**Charlotte-Mecklenburg Planning, Design, & Development**

**SUBJECT:** Administrative Approval for Petition No. Woda Cooper Development, Inc

**PROPOSED DEVELOPMENT: NORTHLAKE CENTRE APARTMENTS**

**FOR PUBLIC HEARING  
 REZONING  
 PETITION # 2019-181**

**RZ1.0**

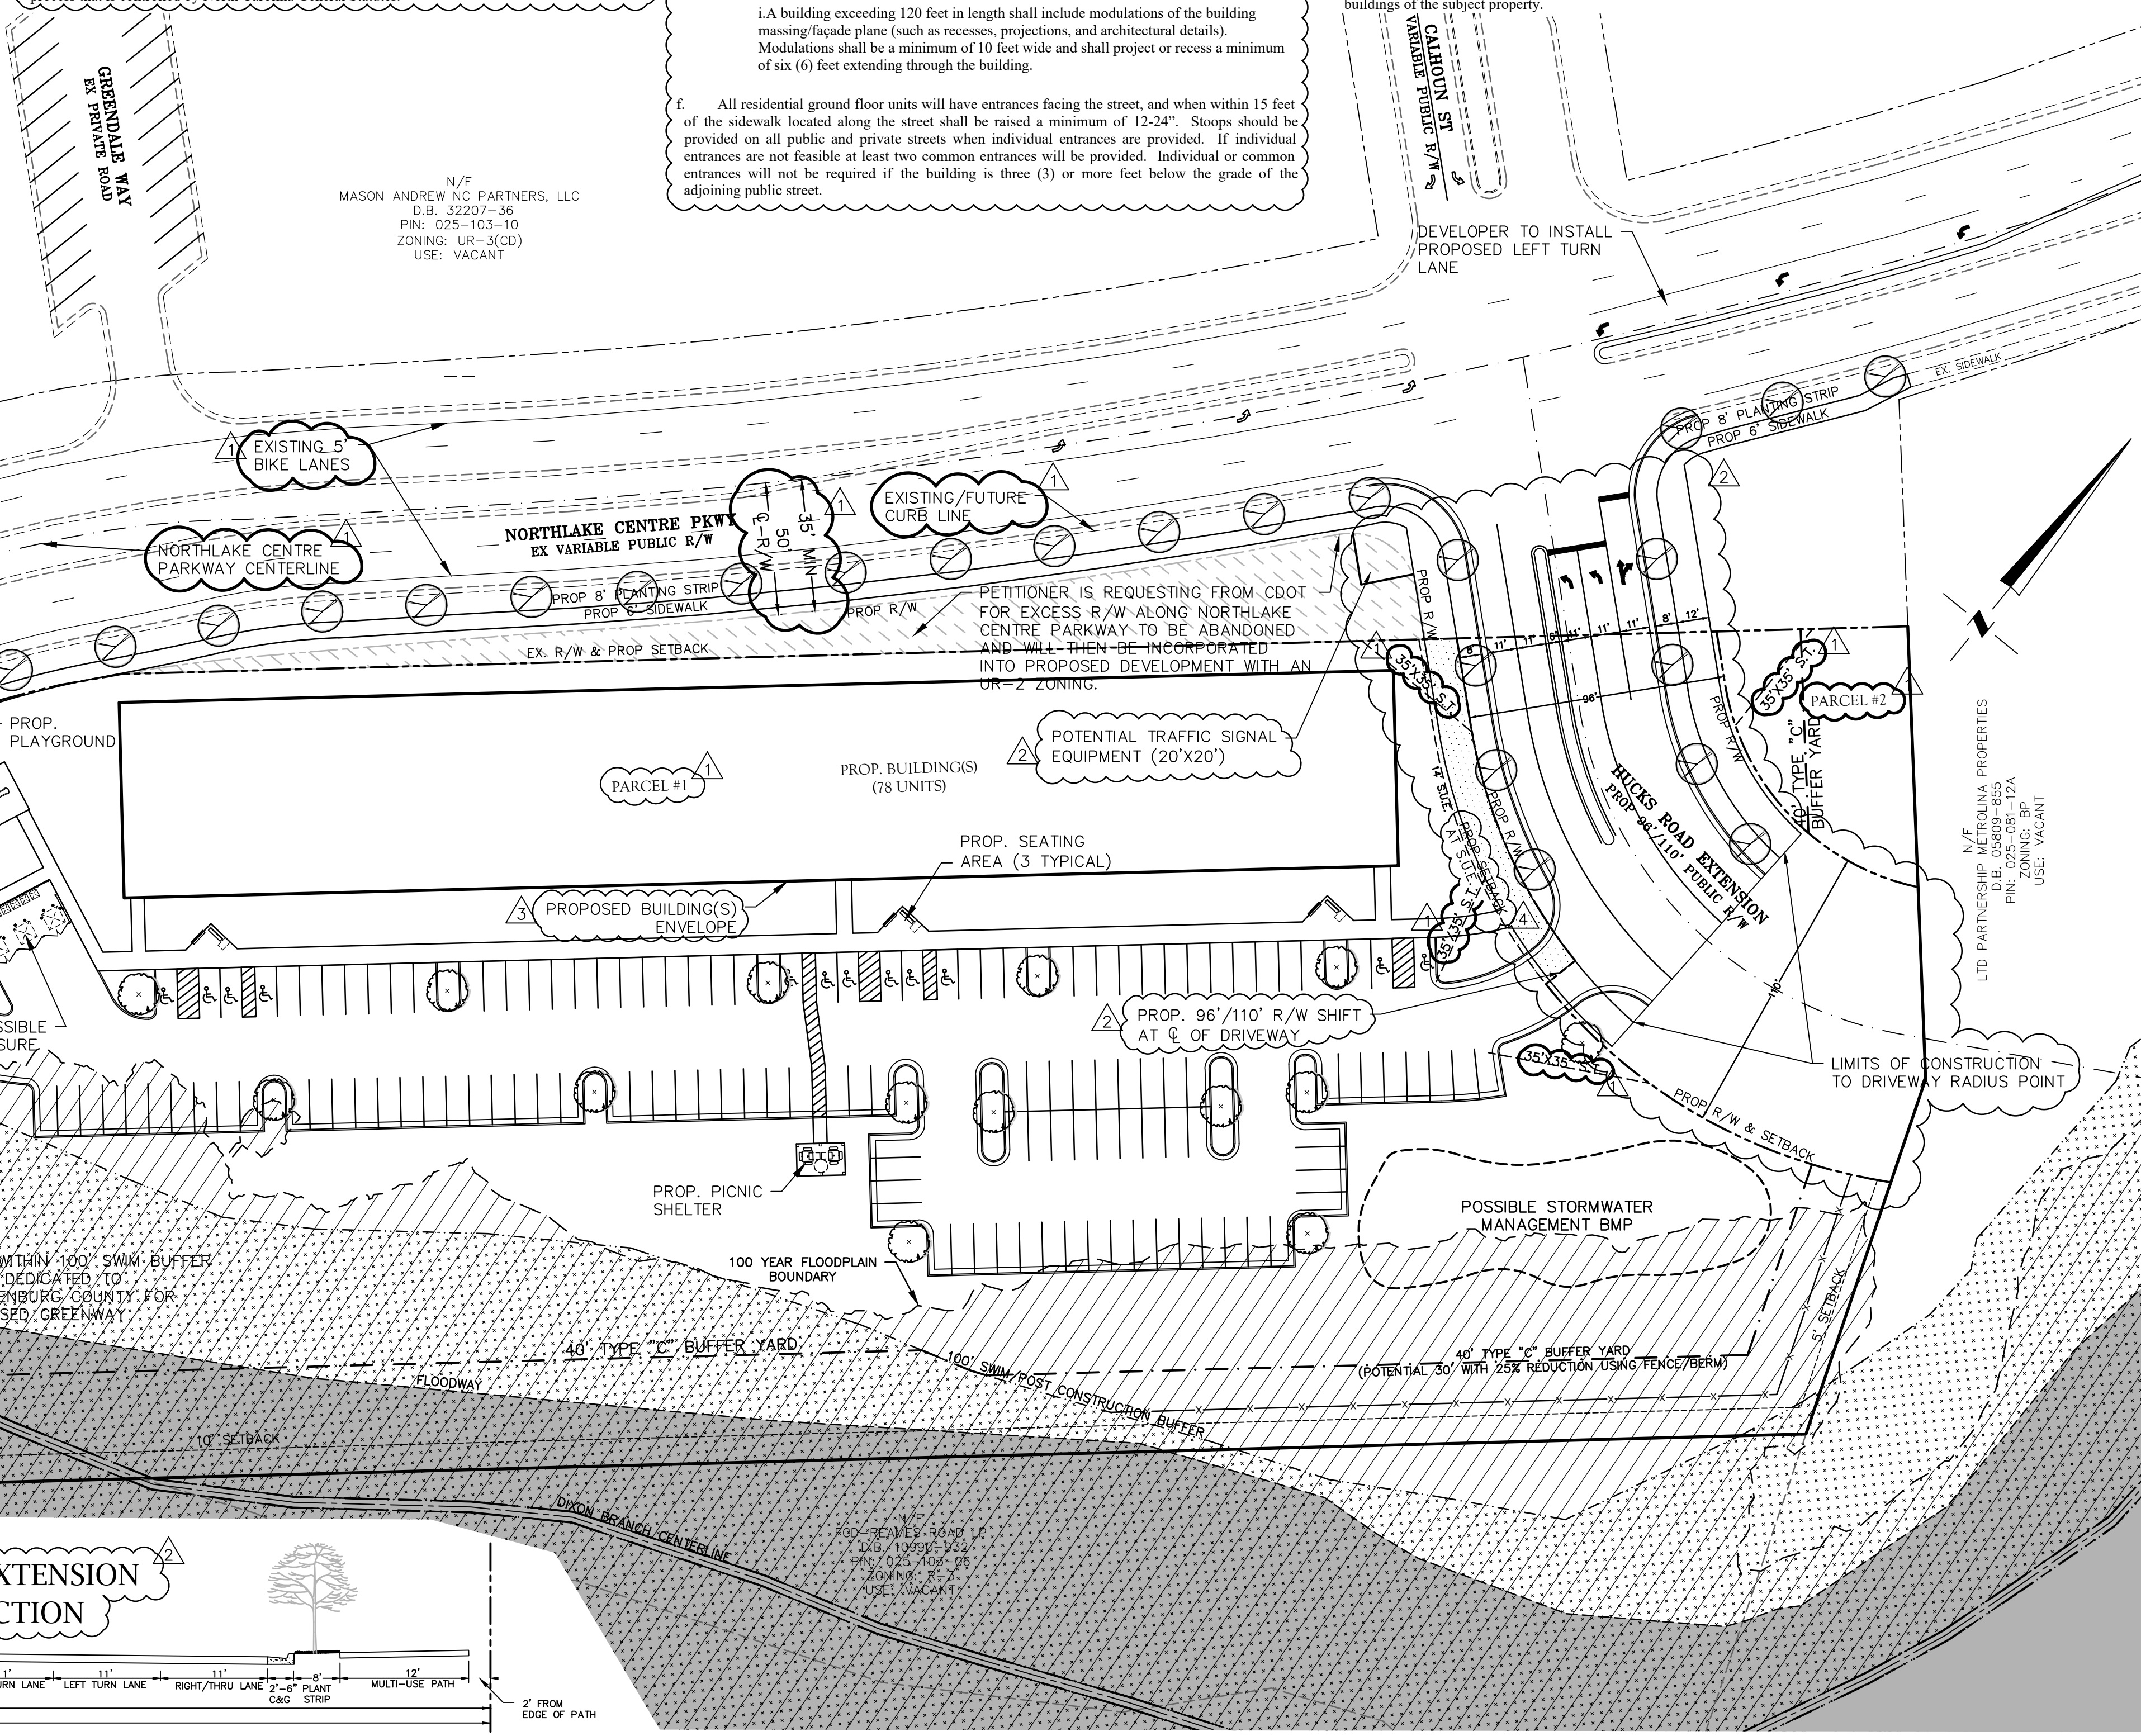
- To modification to a note that the setback will be measured from the future back of curb.

- A 14 foot setback will be provided as measured from the existing or proposed back of curb of Northlake Centre Parkway and from the proposed back of curb of Hucks Road as generally depicted on the Rezoning Plan. Where the right of way is 96' along Hucks Road the setback shall be based on the 14' S.U.E. to provide a uniform setback along Hucks Road.
